Development Assessment Panel

date of meeting: Wednesday 27 May 2015

Subject: DA2014 - 0123 DEMOLITION OF UNITS AND CONSTRUCTION OF A RESIDENTIAL FLAT BUILDING (13 UNITS), INCLUDING CLAUSE 4.6 VARIATION TO CLAUSE 4.3 (HEIGHT OF BUILDINGS) AND CLAUSE 4.4 (FLOOR SPACE RATIO) OF THE PORT MACQUARIE-HASTINGS LOCAL ENVIRONMENTAL PLAN 2011, AND STRATA SUBDIVISION AT LOT 101 DP1122606 NO. 3 CLARENCE STREET, PORT MACQUARIE

This report considers a development application (DA) for demolition of units and construction of a residential flat building (13 units), including clause 4.6 variation to clause 4.3 (Height of Buildings) and clause 4.4 (Floor Space Ratio) of the Port Macquarie-Hastings Local Environmental Plan 2011, and strata subdivision at the subject site.

Figure 11a & 11b – View impact 4 storey example

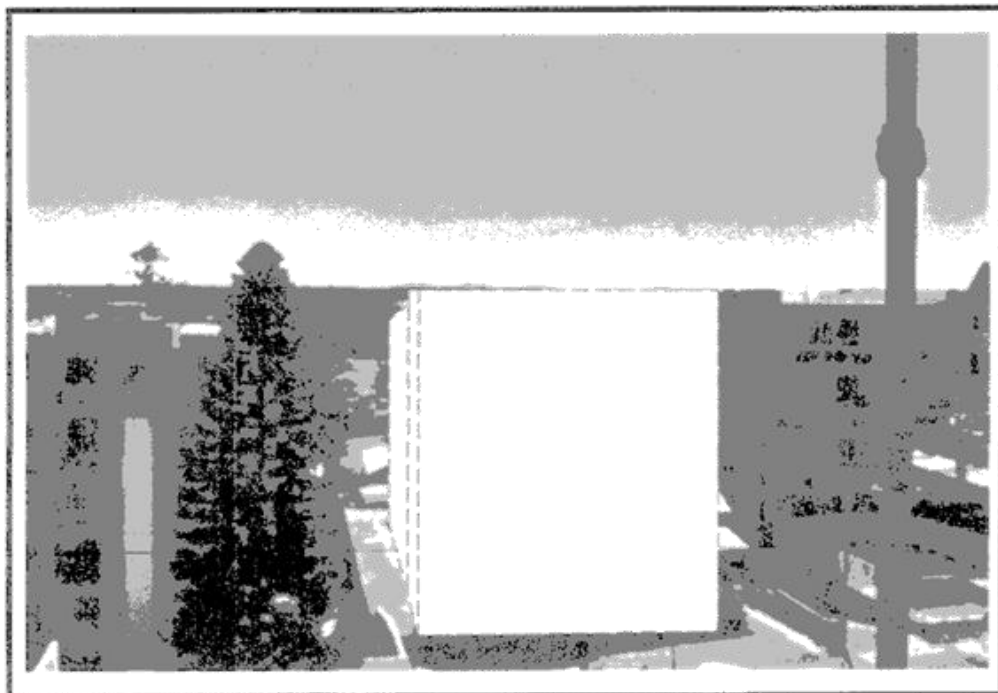
Figure 9 – Indicative view lines. The applicant's knowledge of our view is totally incorrect as enclosed photos show. Is only what the applicant would like council to think we view or don't view.

Figure 11a & 11b show 4 story example as worst case scenario if it is within legalities? compared to Figure 12, 19 metre example (6 story) which is totally out of character for such a small site compared to adjacent property's.

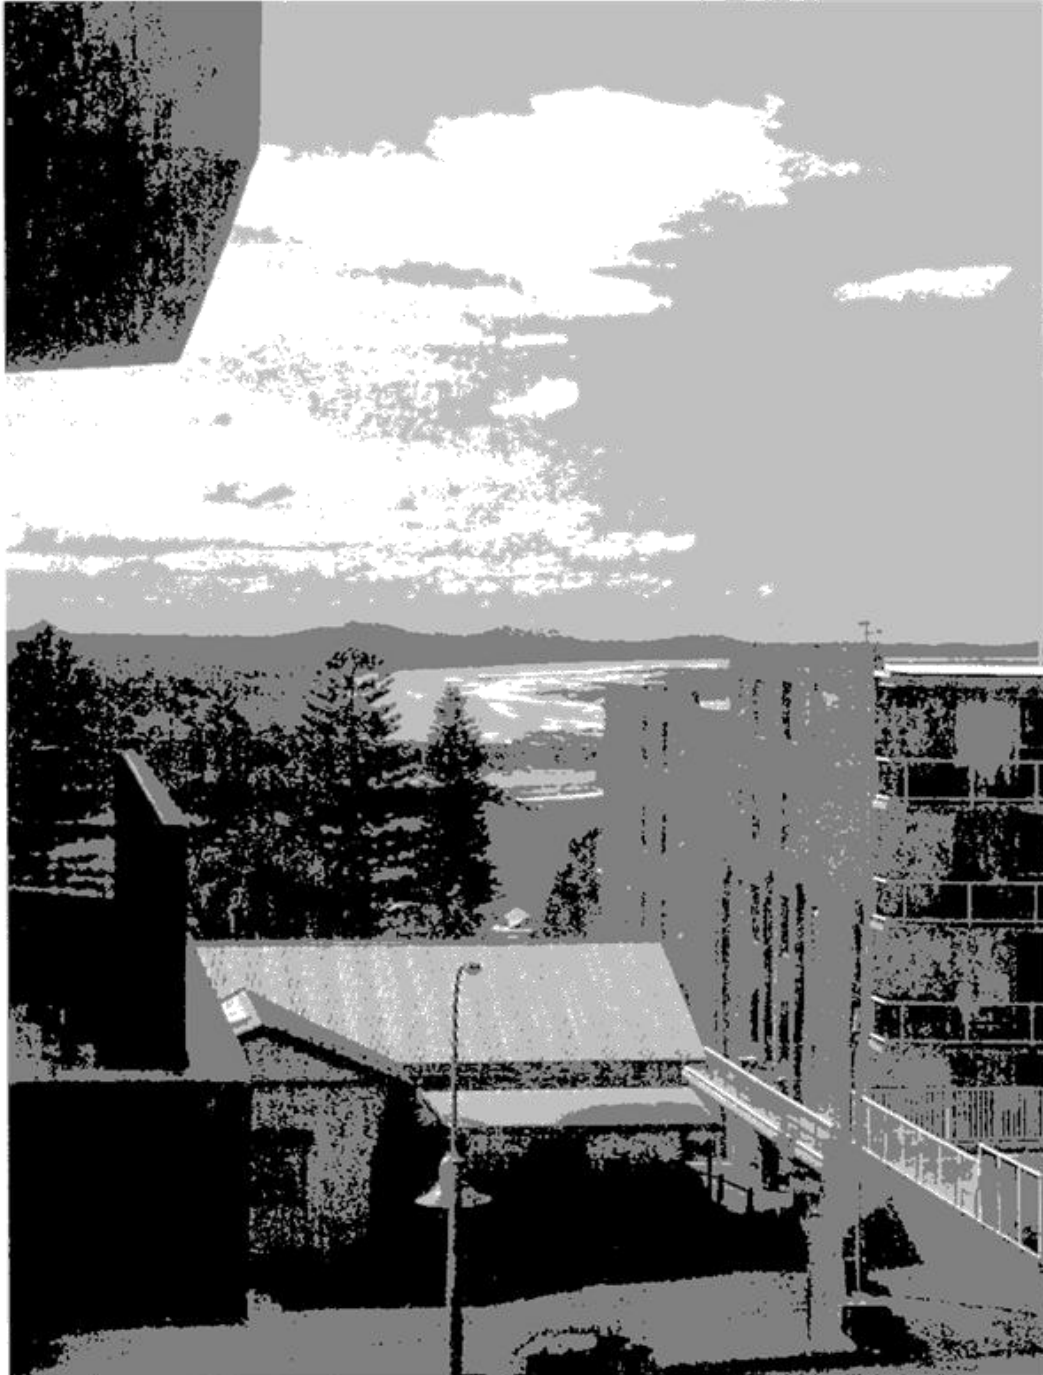
Due to being on the School St side of the building, from inside I overlook the school
grounds opposite. However I do have views across the road when standing
anywhere on the balcony and any acknowledgement of this was not considered in
the Development Proposal. (see the attached picture).

I accept that the majority of this view will be eventually blocked by a development. I
object to the current Development Proposal due to the excessive height when
compared to the adjacent buildings. This appears to be about 2 storeys higher than
the existing neighbouring buildings and would have an impact on the overall
streetscape.
